### REMARKS

## Appendix A. Identification of Amended Material

FIG. 6

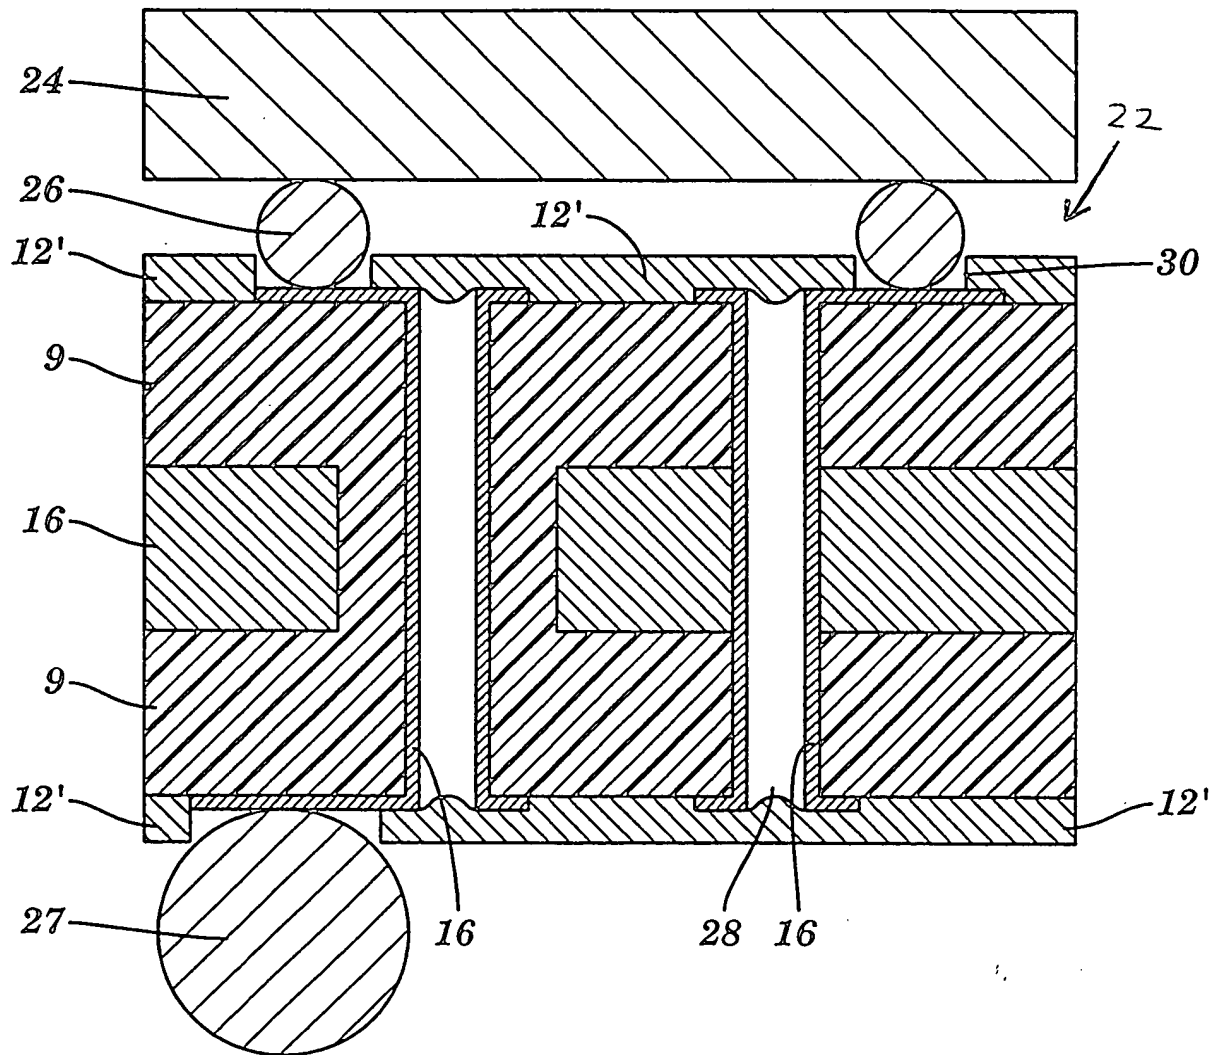
The Examiner objected to the drawings as allegedly “failing to comply with 37 CAR 1.84(p)(5) because they do not include the following reference sign(s) mentioned in the description: 22 (page 19, line 19 first mentioned). A proposed drawing correction or corrected drawings are required in reply to the Office action to avoid abandonment of the application. The objection to the drawings will not be held in abeyance.” In response, Applicants amended FIG. 6 to show reference numeral 22.

Fig. 6 shows an integrated circuit chip carrier 22 that includes the coated filled body 9. The structure of the chip carrier 22 is generally known to those of ordinary skill in the art and although the precise form may vary, the chip carrier 22 of the present invention generally includes the following components: (1) dielectric layers including filled bodies 9; (2) electrically conductive layers 16; (3) plated through holes 28; (4) solder chip connectors 26; (5) ball grid array solder connector 27; (6) electrically conductive pads 30; [(7) integrated circuit chip 24;] and ([8]7) thermosetting resin 12' now used as a solder mask. The integrated circuit chip 24 is coupled to the chip carrier 22 through the solder connectors 26.
